CITY OF ALBUQUERQUE

**RE: McMahon Market Place – Lot 9C
Grading & Drainage Plan
Engineer's Stamp Date: 12/21/23
Hydrology File: A11D011J**

McMahon Marketplace Lot 9a and Lot 9b Drainage Study

McMAHON MARKET PLACE
NEW SHELL BUILDING
5770 McMAHON BLVD NW
ALBUQUERQUE, NM 87114
GRADING & DRAINAGE PLAN

SHEET NO:
CG1.0

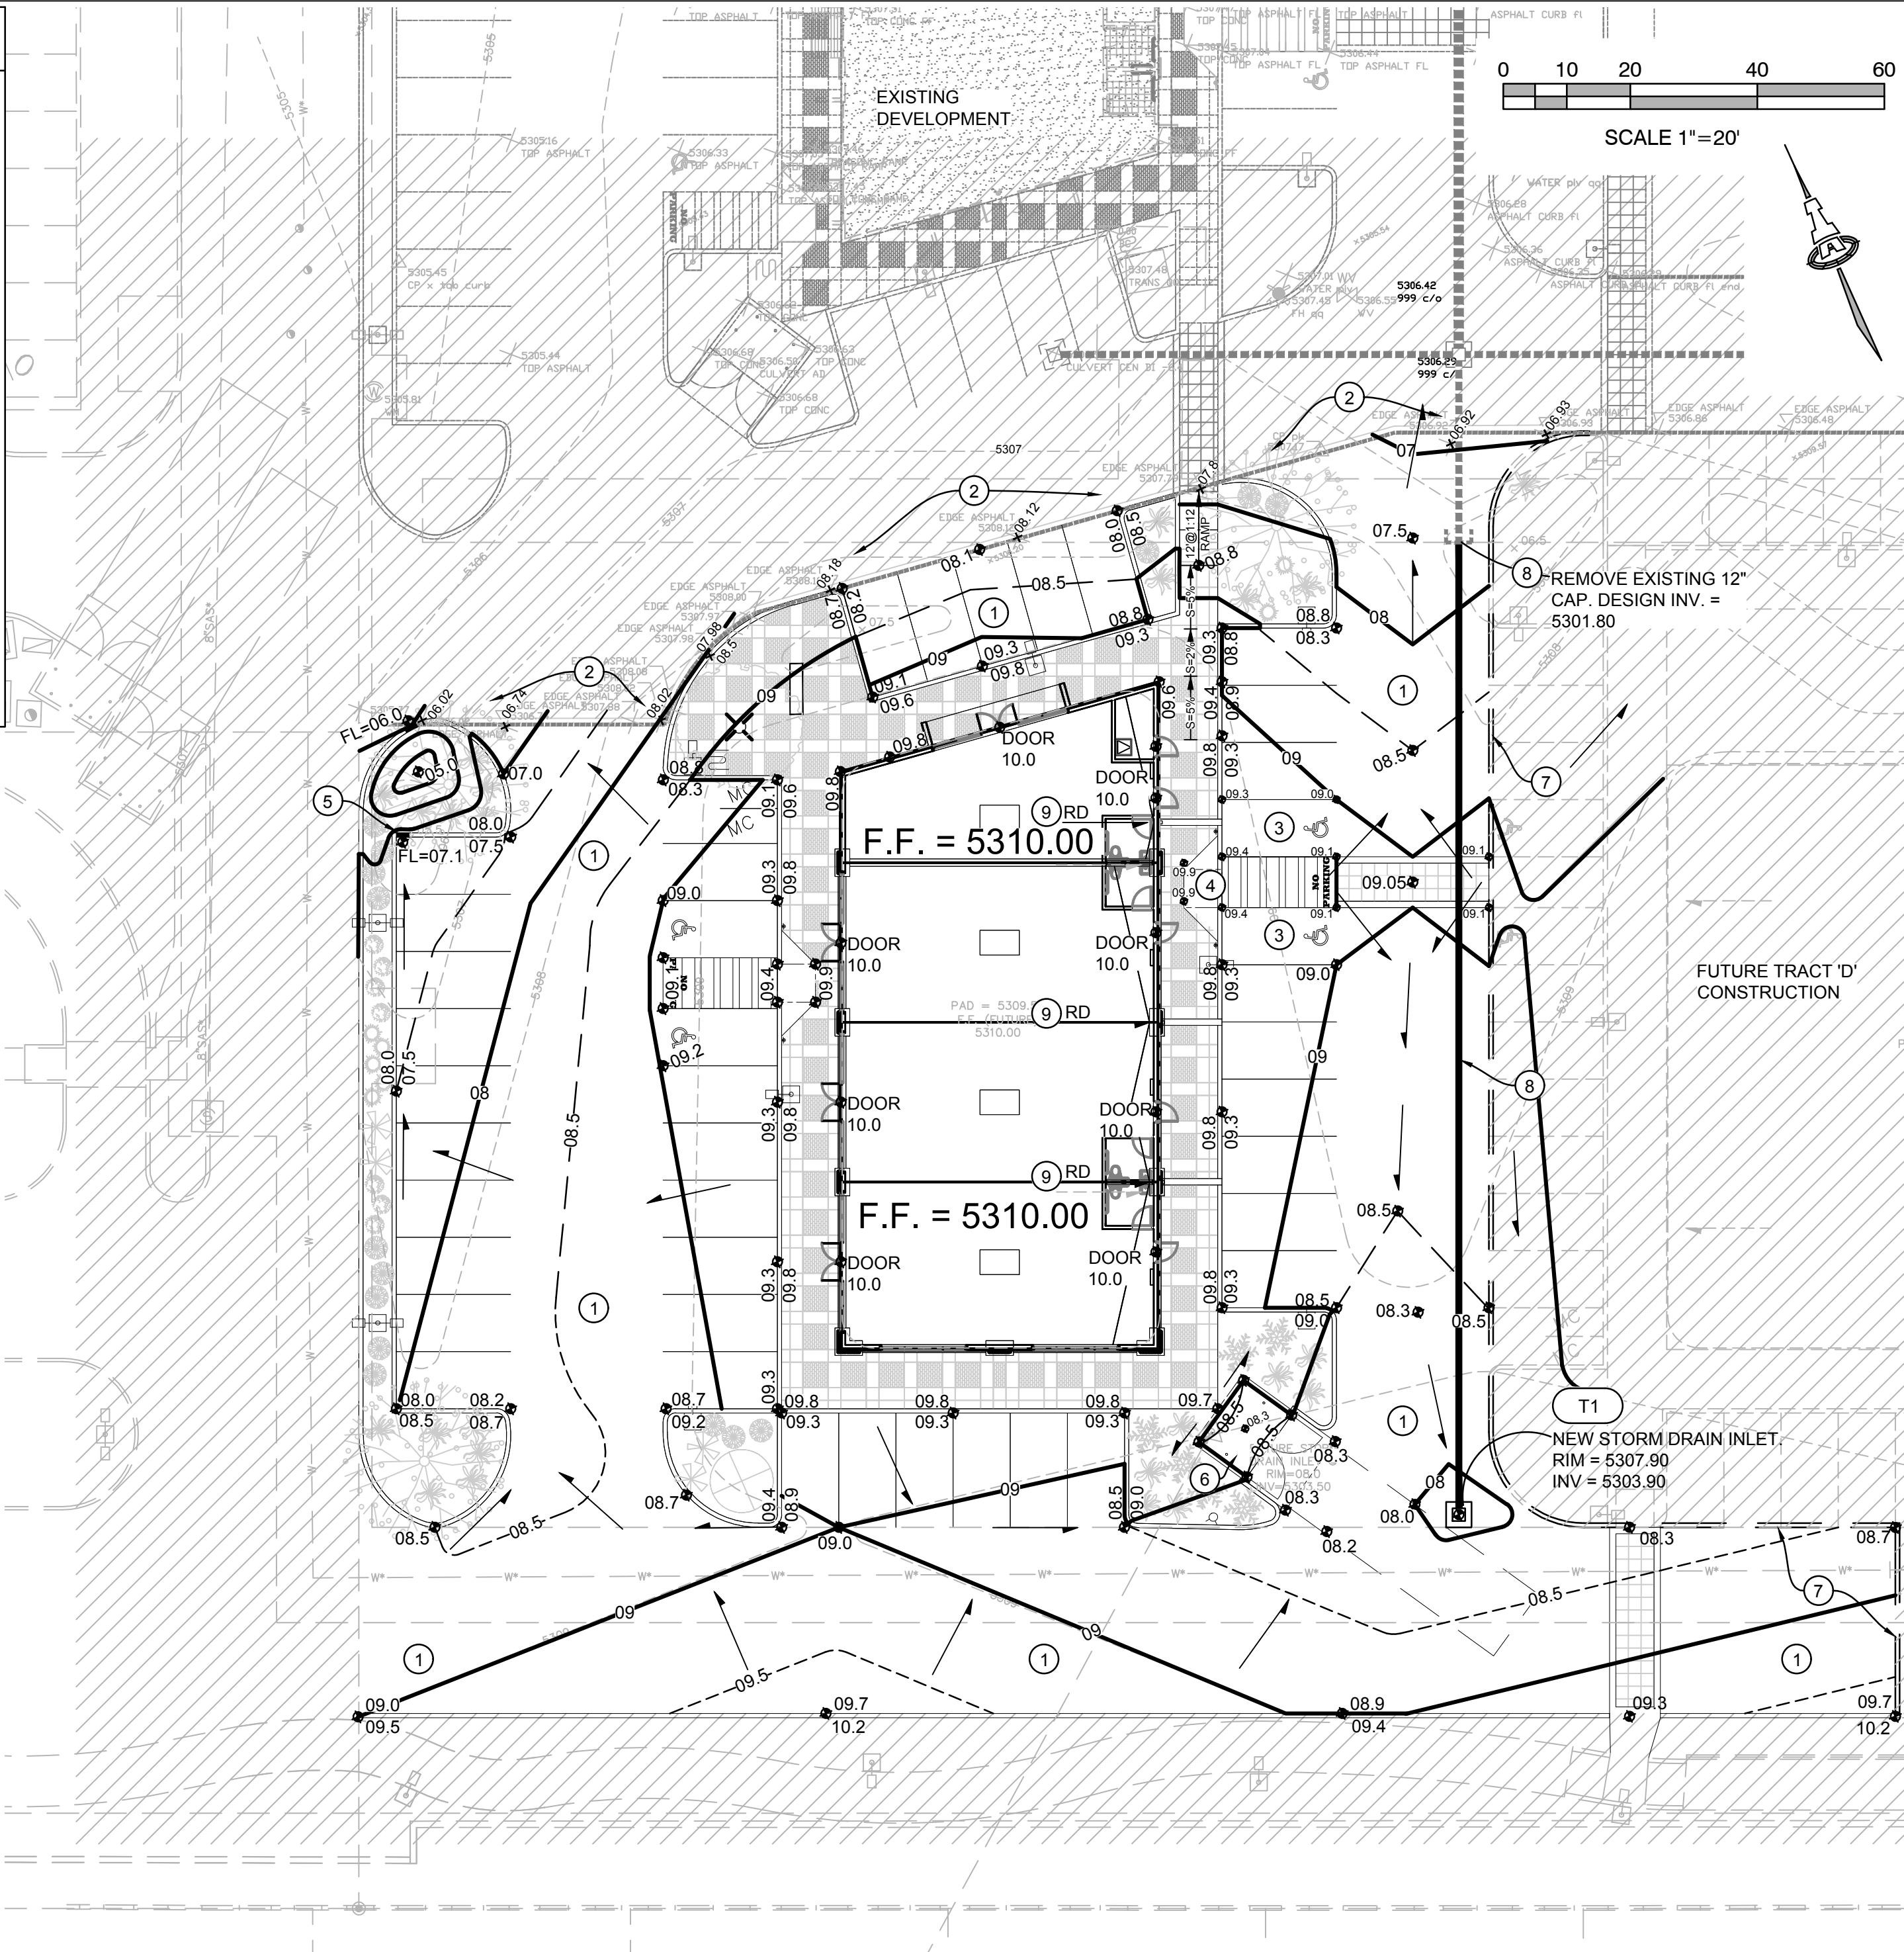
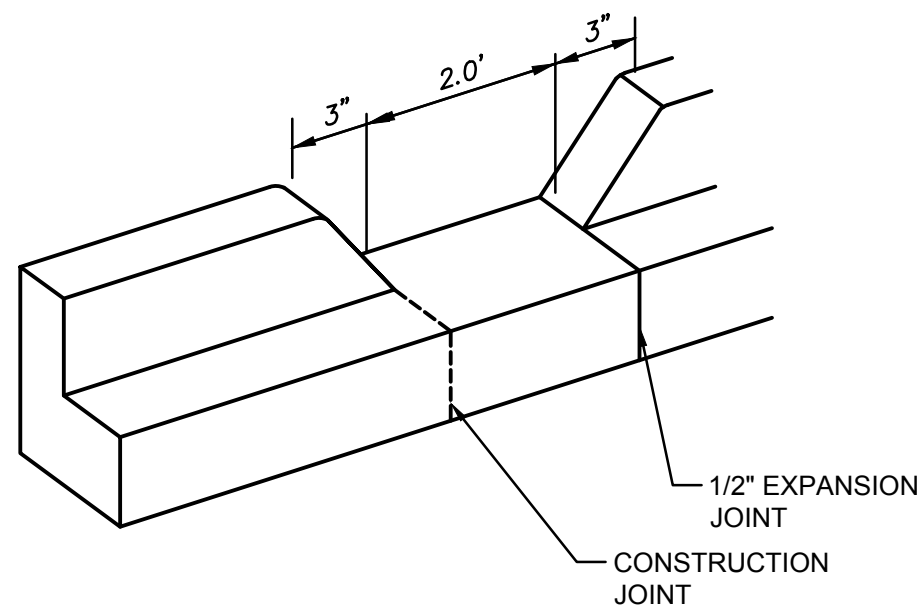
Based upon the information provided in your submittal received 12/20/2023, the Grading & Drainage Plan is approved for Building Permit and Grading Permit. Please attach a copy of this approved plan in the construction sets for Building Permit processing along with a copy of this letter.

1. Engineer's Certification, per the DPM Part 6-14 (F): *Engineer's Certification Checklist For Non-Subdivision* is required.

As a reminder, if the project total area of disturbance (including the staging area and any work within the adjacent Right-of-Way) is 1 acre or more, then an Erosion and Sediment Control (ESC) Plan and Owner's certified Notice of Intent (NOI) is required to be submitted to the Stormwater Quality Engineer (Dough Hughes, PE, jhughes@cabq.gov, 924-3420) 14 days prior to any earth disturbance.
